Subject: FW: Approval to store scrap metal in the cell 4B area, Galena C&D Landfill, Permit 738, Galena, CK Co.
Attachments: 2019-12-11 Permit Mod scrap mtl storage apprvl.pdf

Re: Request to store scrap metal in the Cell B4 area at the City of Galena construction and demolition landfill, Permit 738, Galena, CK Co.

AREA "B" BASE GRADE PLAN
 GALENA C&D LANDFILL
 OLD HWY 66

FIGURE 1

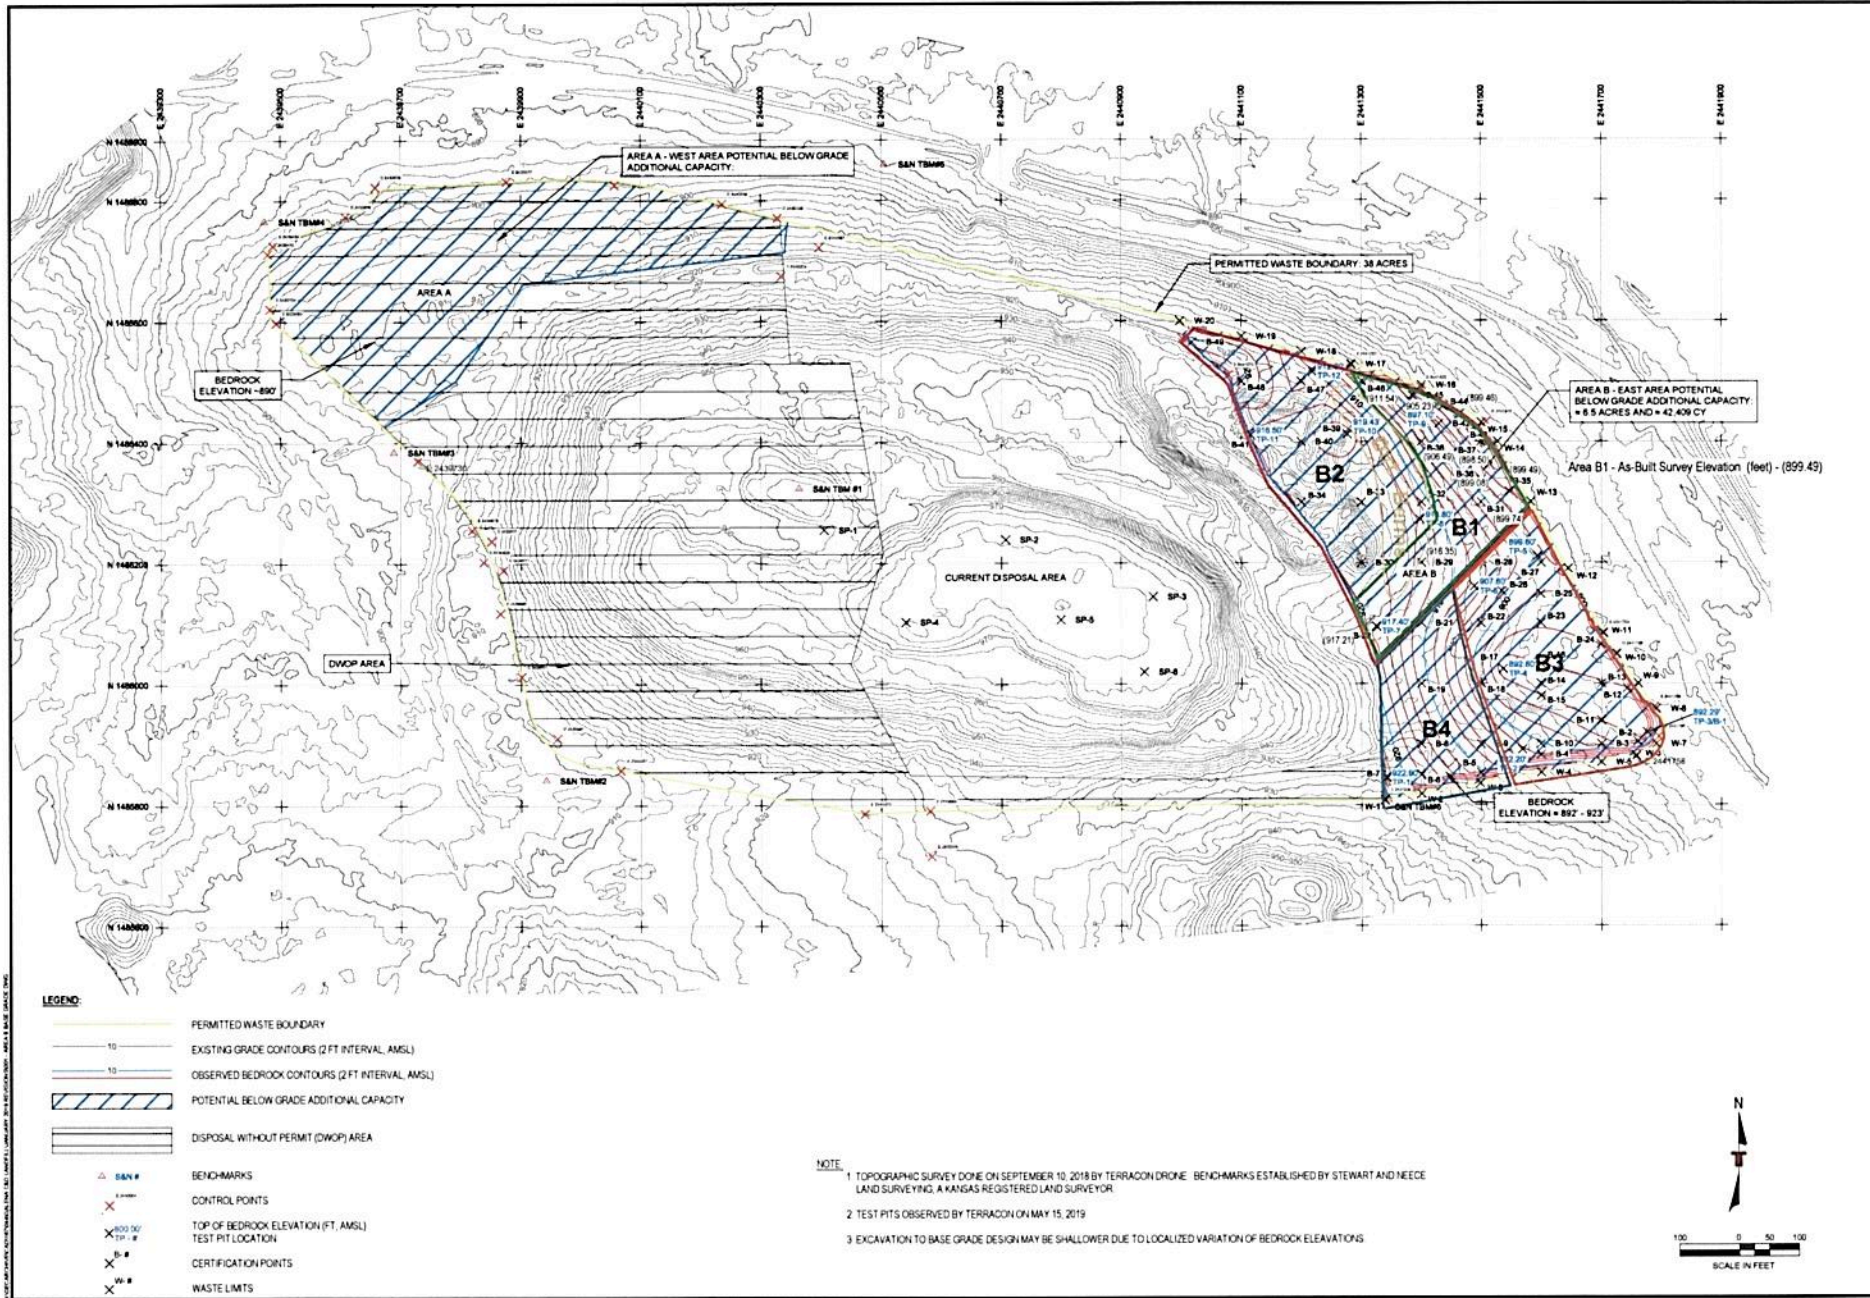
Good morning Charley,
The area we are wanting to use is permitted but not yet being used. It is area B4 on the attached map.
Thanks,
Gregg

Greg,
You propose to "store / stockpile the recovered metal on the landfill. We will be using an inactive area that has been partially excavated for cover." By "inactive" do you mean an area that has been permitted for disposal but not yet used for disposal? Or do you mean an area not permitted for disposal? I just wish to be sure what you are requesting. Perhaps you could note the proposed storage site on the attached map and add any notes on the map providing clarification. You will not be stuck using a specific/exact area you mark on the map, but I just wish to be sure of the general area you are proposing to store the wastes.

Due to the dropping price of scrap metal, we would like store / stockpile the recovered metal on the landfill. We will be using an inactive area that has been partially excavated for cover. Upon the recovery of scrap prices the metal will be removed and sent to the recycler.

The request is conditionally approved. The approval condition is: The metal salvaging will be performed in accordance with Kansas Administrative Regulation 28-29-308(1)(2 & 3), i.e., "the salvage operation and salvaged materials shall be controlled to prevent interference with the prompt disposal of C&D wastes," and "all salvage operations shall be conducted in a manner that does not create a nuisance."

This approval is considered a minor operating plan modification pursuant to General Condition 4(b) in Permit 738. Please amend the operating plan for this facility consistent with your request and this approval. One way to accomplish this would be to insert copies of this approval letter into the approved operations plan. By copy of this letter, the amendment is being forwarded to KDHE's District Office for their file as well.
